Access Compliance Report

Public Rights-of-Way

Intersection ID: 48000	Main Street: LANZERAC_MANOR_DR	Cross Street: CLYMER_CT	Location: SE
ADA ID: 9A77BA83E95B	Ramp Type: Perp	Initial Pass/Fail: Fail	Overall Compliance: No
		Severity Score: 8.75

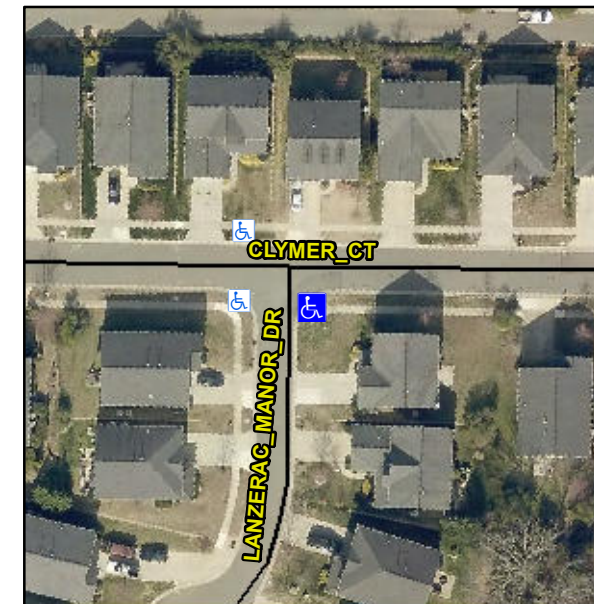
Not Found, R304.5.1

Remove & Replace Entire Ramp.
